M-4.0t, TFM-4.0, TFM-42, TFM-45 MAGNETIC FIELD POWER AMPLIFIERS SERVICE MANUAL

Engineering Change Orders for Model M-4.0t Magnetic Field Power Amplifier

CARVER CORPORATION SERVICE BULLETIN

Model M-4.0t

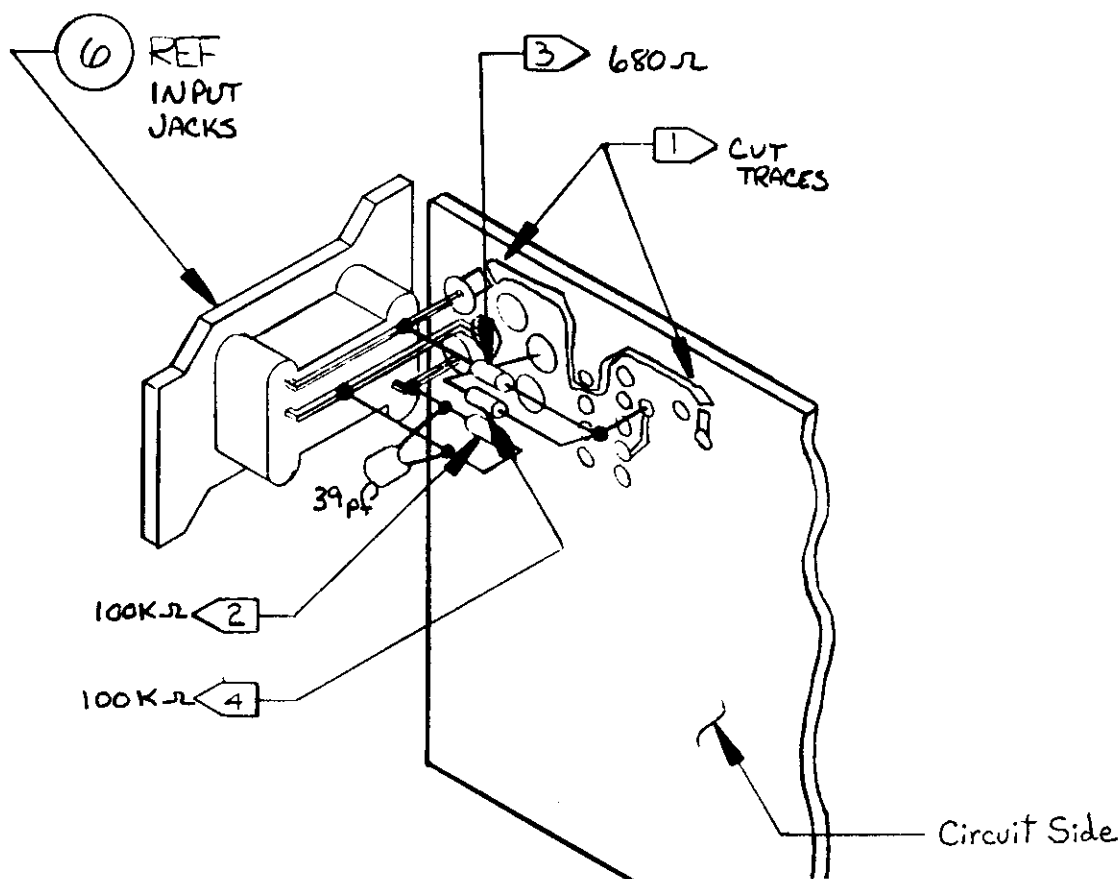
Reason: Too much "BUZZ" (60Hz) with input jacks unterminated.

Procedure: Route Transformer Secondary wire bundle behind terminal strip. Use a snake lug on back side of terminal strip to hold wires. On inside front transformer mounting bolt remove nut and scrape metal clean. Add a #6 solder lug and retighten mounting nut. Add 7 inches of Blk #22 wire from the solder lug to main power supply board ground and route with the secondary wires, with wraps at every 2 inches. Remove R61 (2.2K ohm) and R60 (470K ohm) on Power Supply PCB. Add Qty (2) 100K 1/4W and Qty (1) 680 ohm as shown. from ECO 900

Delete: R60 251-00078-03 2.2K 1/4W
R61 251-00134-00 470K 1/4W

Add: Qty. 2 251-00118-03 100K 1/4W
Qty. 1 251-00066-03 680 ohm
Qty. 1 111-20051-00 #6 lug
Qty 1 401-10502-00 wire #22 ga

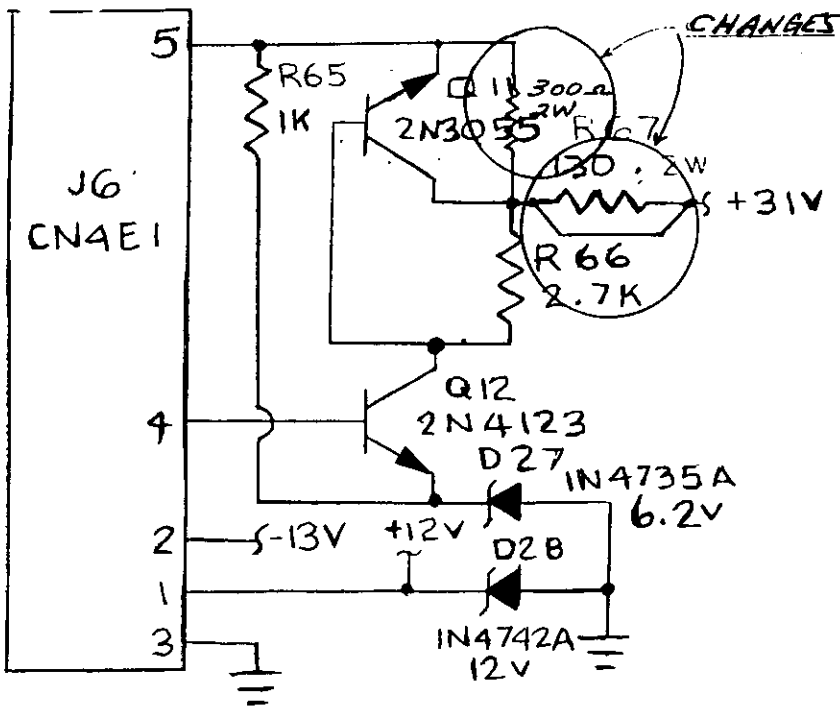
Procedure: 1) On the power supply board install a jumper wire across R67.
2) On the meter board install a 1K ohm 1/4W resistor across R453 on the foil side of the board. (SEE FIGURE 1)
3) On the power supply board install a 300 ohm 2W resistor on the foil side of the board. Be sure to space the resistor for proper cooling. (SEE PAGE 2)

Delete: Qty-1 255-20072-00 130 ohm 2W This resistor is bypassed by the jumper wire.

Add: Qty-1 255-20083-00 300 ohm 2W
Qty-1 251-00070-00 1K ohm 1/4W
Qty-1 401-30013-00 jumper .8"

FIGURE 1

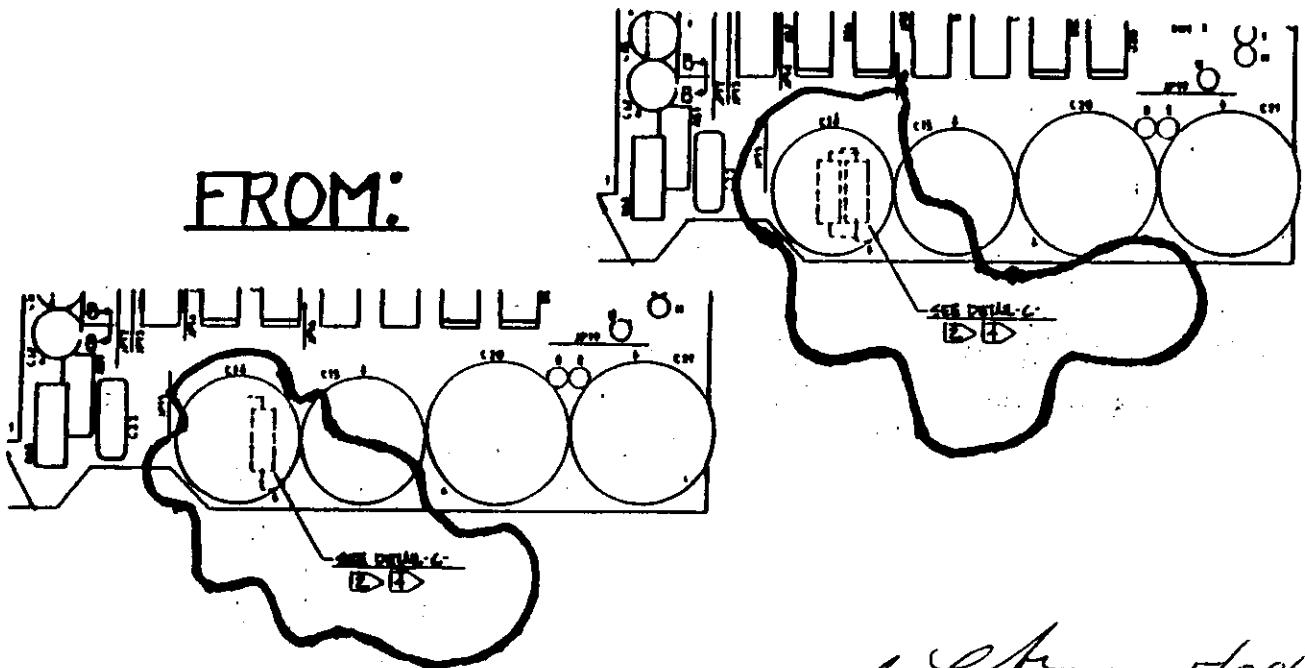
Procedure: At location R69 remove an 820 ohm 2W resistor. Replace the resistor with two 680 ohm 2W resistors in parallel.
*SEE FIGURE 1

Delete: Qty-1 253-20100-00 820 ohm 2W

Add: Qty-2 255-20095-00 680 ohm 2W

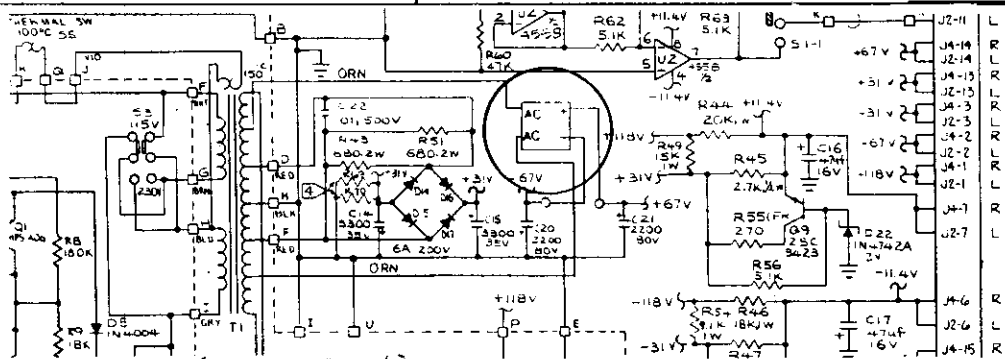
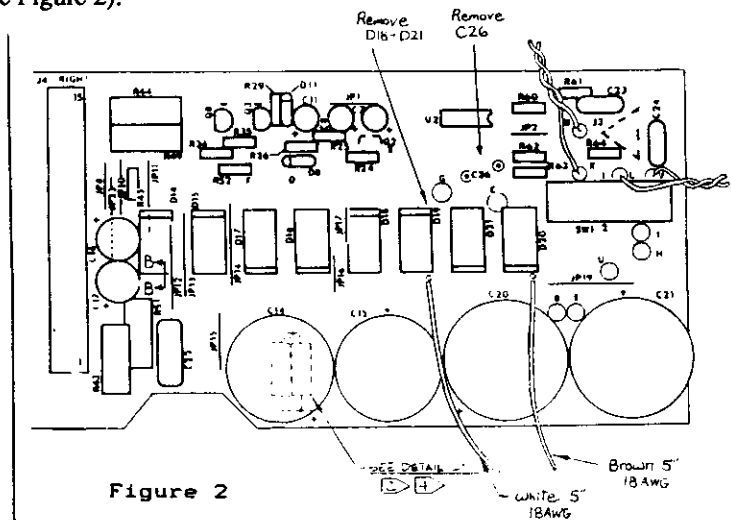
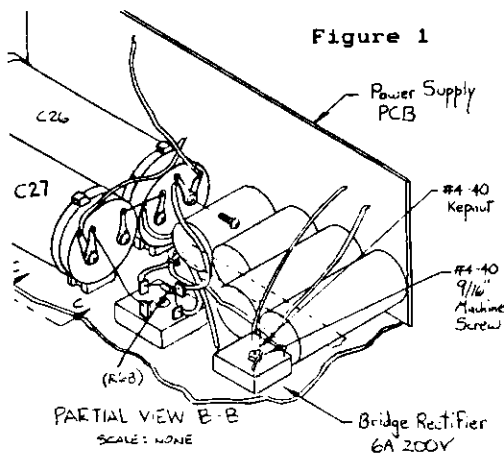
1. Remove D18, D19, D20, D21 from power supply board.
2. Install the Bridge Rectifier (319-00030-00) as shown in Figure 1 using a 4-40x9/16" machine screw and a 4-40 kepnut.
3. Remove orange secondary wires from location 'C' and 'G' on the power supply board and route them to the AC pins of the bridge rectifier. Route the brown 18AWG wire from the positive pin of the rectifier to the hole left of the cathode of D20. Route the white 18AWG wire from the negative pin of the rectifier to the hole left of the anode of D19.
4. Remove C26 (2 wires forming air capacitor - see Figure 2).

DELETE	ADD
Qty 2 Wire 22AWG (Air capacitor C26) 401-10629-00	Qty 1 Wire 18AWG Brown 5" 401-10129-01
Qty 4 Diode 6A, 200V (D18, D19, D20, D21) 320-20010-03	Qty 1 Wire 18AWG White 5" 401-10158-00
	Qty 1 Machine Screw #4-40x9/16" 151-20004-00
	Qty 1 Kepnut #4-40 152-10001-00
	Qty 1 Bridge Rectifier 6A, 200V 319-00030-00

Figure 1A

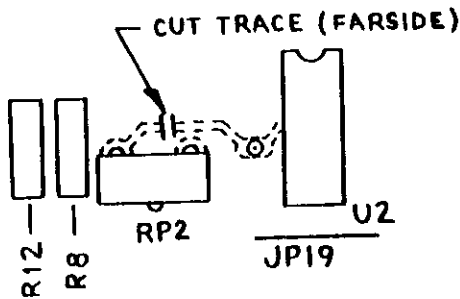
On foil side of each board, cut trace between RP2 and U2 pin 3. (See Figure 1A).

Figure 1B

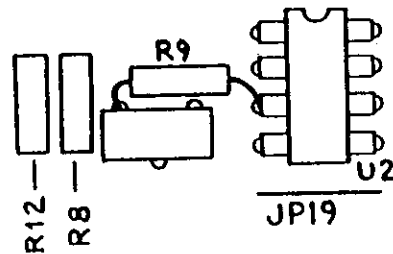
Solder R9, 750 ohm 1/4W resistor, between RP2 and U2 pin 3. (See Figure 1B).

Figure 2

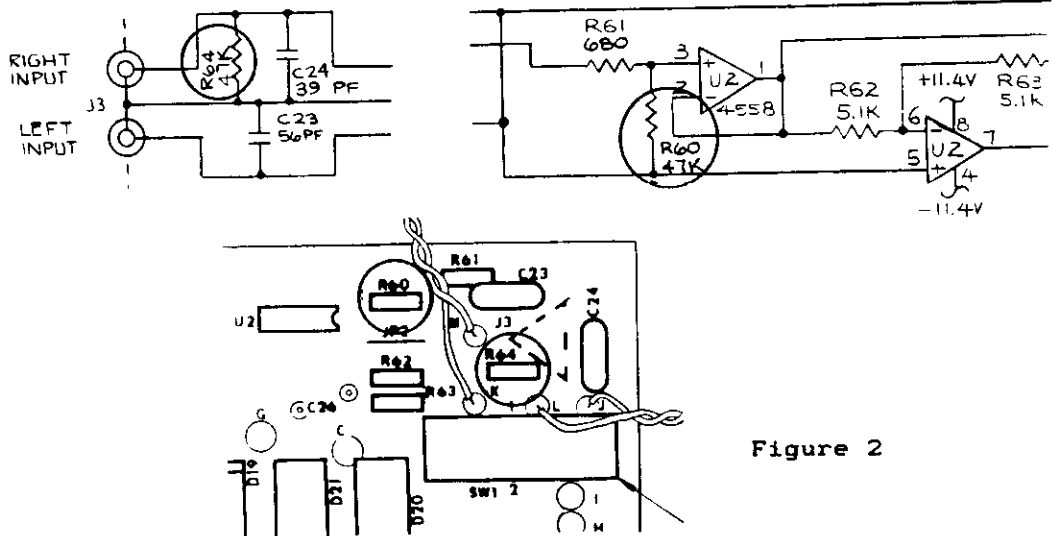
1. Replace R60 and R64 on the power supply board with 47k ohm 1/4W resistors (251-00110-00). See Figure 2.

Figure 1

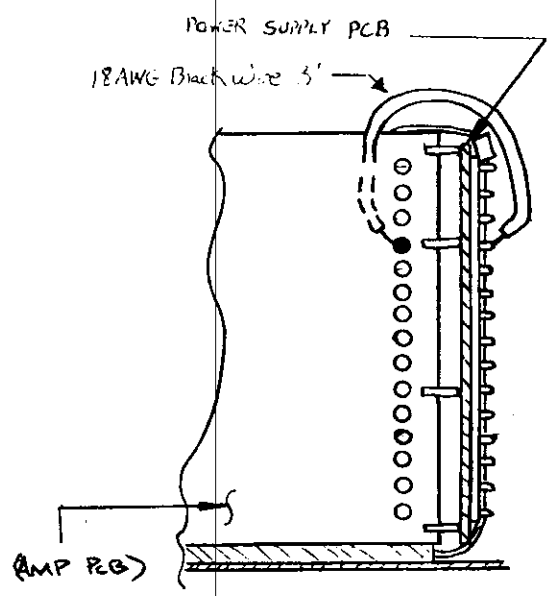
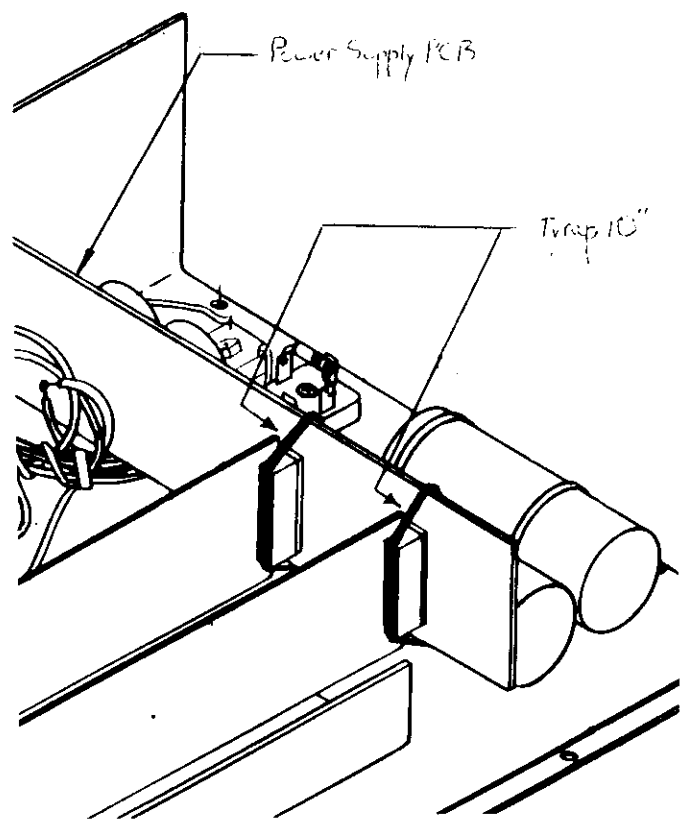
1. Solder one 3" 18 AWG black wire between J2 pin 12 on the power supply board and J2 pin 12 on the left amp board. Solder another 3" 18 AWG black wire between J4 pin 12 on the power supply board and J2 pin 12 on the right amp board (see Figure 1).
 Note: This step does not need to be performed if the connectors (J2 and J4) are gold plated.
2. Tyrap power supply board and amp boards together as shown in Figure 2.

DELETE	ADD Qty 2 Tyrap 10" 159-50005-00 Qty 2 Wire, 18AWG TEW, Black 3" 401-10102-00
--------	---
